ACTIONS
CITY OF CHARLOTTESVILLE
BOARD OF ARCHITECTURAL REVIEW
Regular Meeting
September 15, 2020 – 5:30 p.m.
Remote meeting via Zoom

**CITY OF CHARLOTTESVILLE
BOARD OF ARCHITECTURAL REVIEW
STAFF REPORT**
September 15, 2020

BAR 20-09-01

Renaissance School - replace five windows

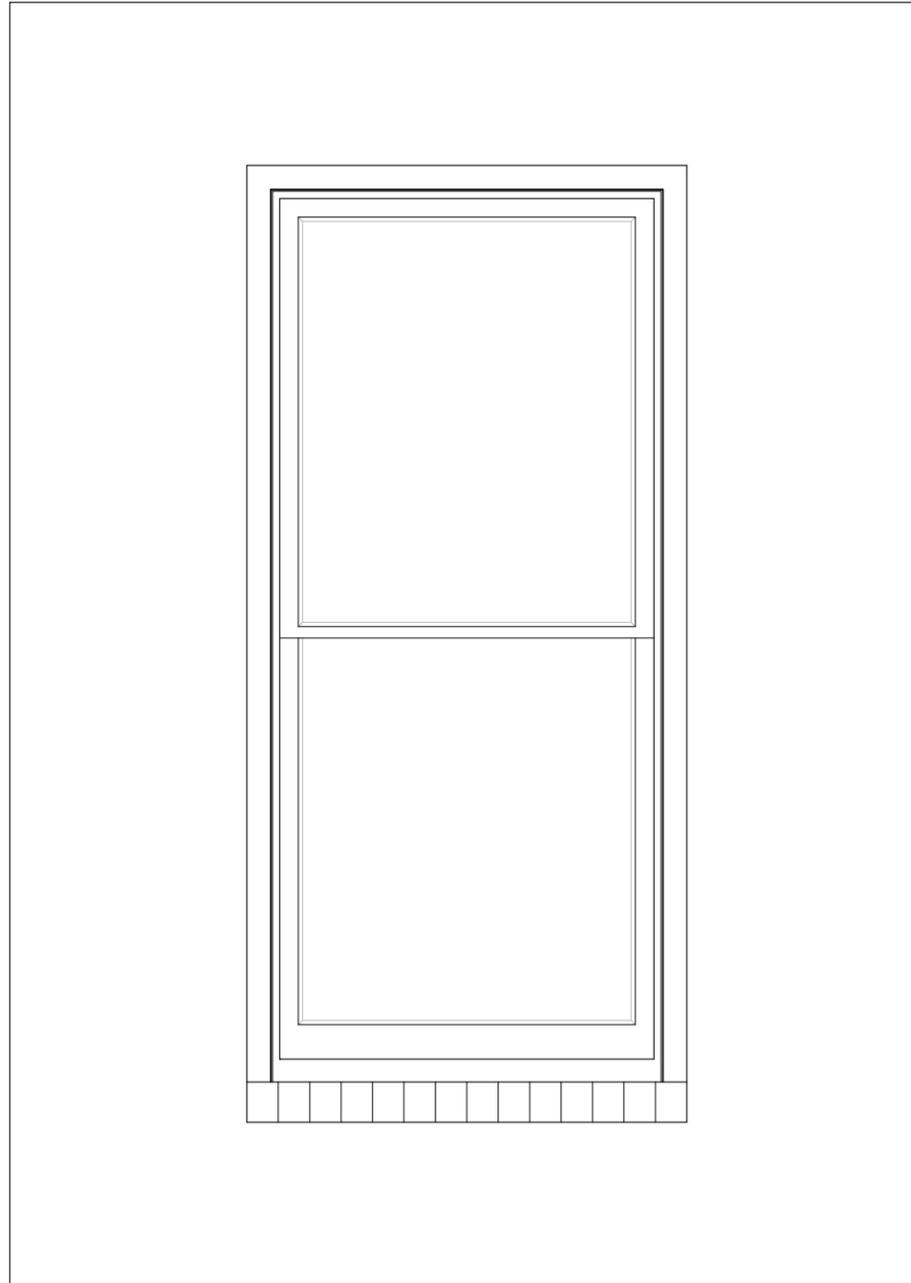
RS would like to also replace these windows using the detail below.
Additional Revisions-24 August 2020

REMOVE EXISTING DOOR AND FRAME, FILL IN MASONRY AROUND NEW WINDOW TO MATCH EXISTING OPENING HEIGHT AND WIDTH.

2020 Google Streetview (Proposed new fence)

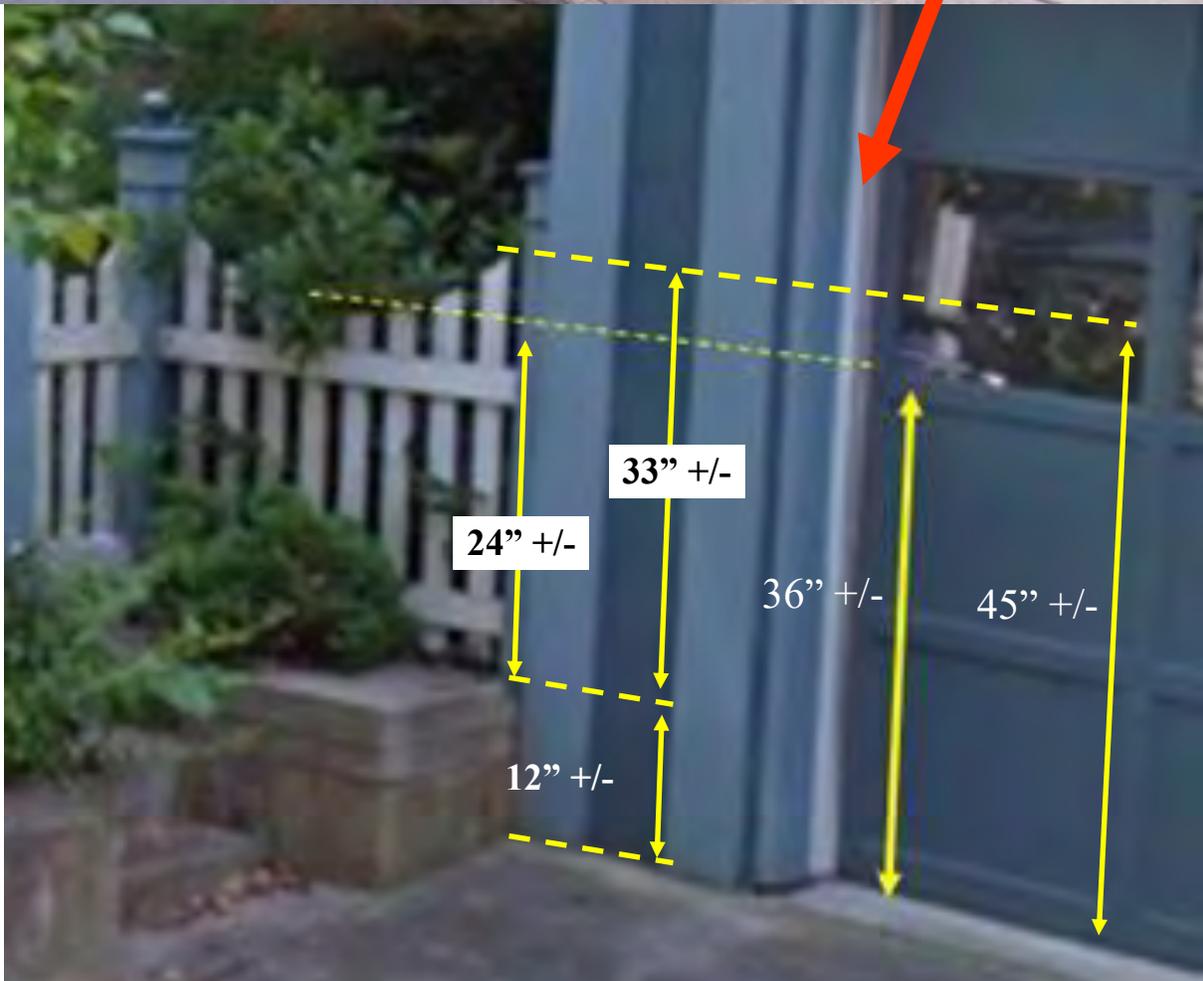
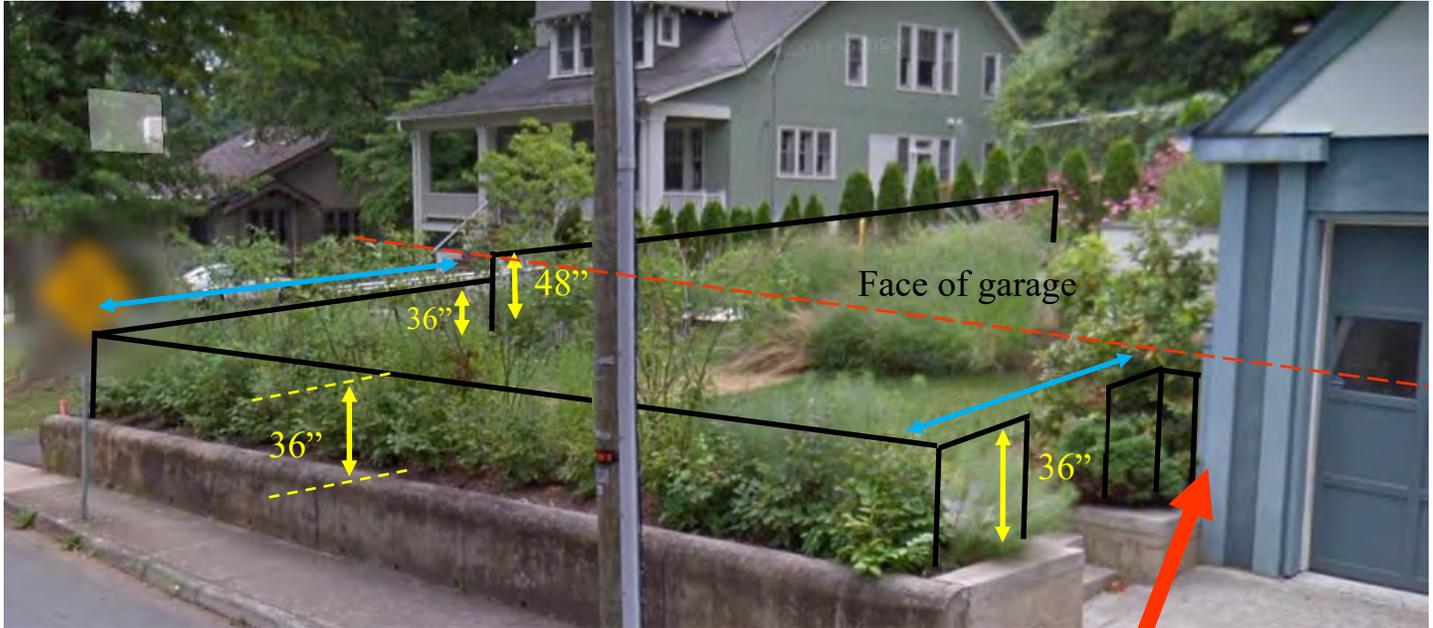
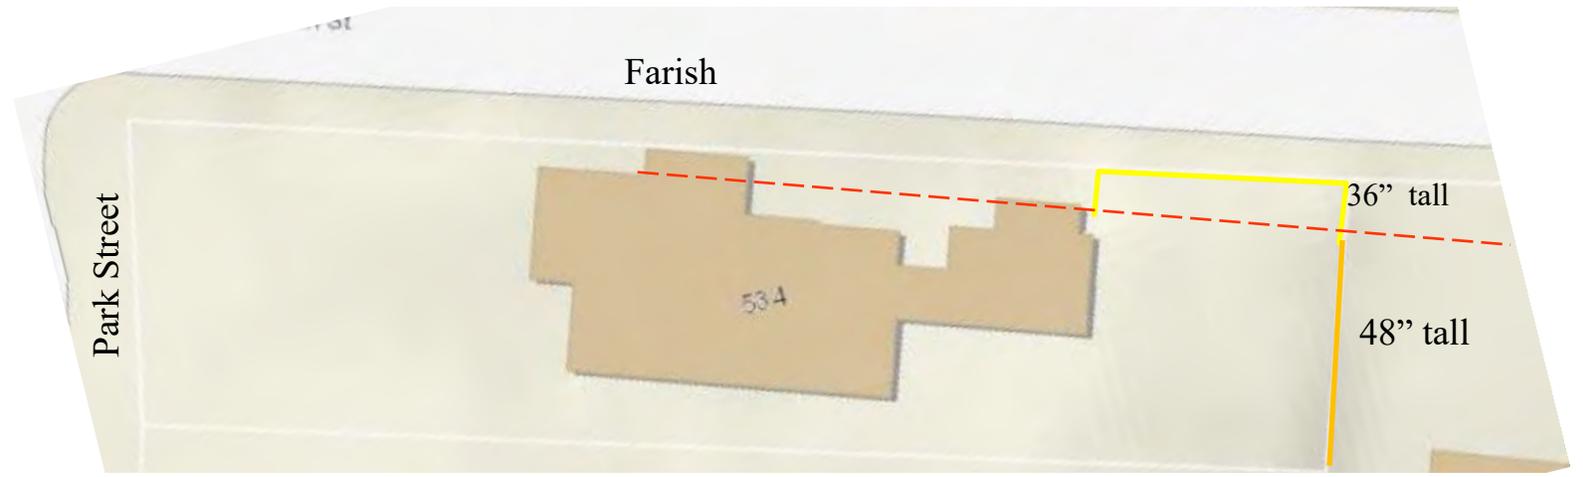
The rear yard is elevated with an approximately 18” high concrete wall. The proposed 36” tall fence results in a height that exceeds the recommended guidelines—fence should not exceed 4-ft in height from the sidewalk; however, until a few years ago, there was a 33” tall wood fence here (see photos) with posts approximately 48” in height. The proposed metal fence is of a similar height and less visible than the wood fence.

Staff recommends approval as submitted.
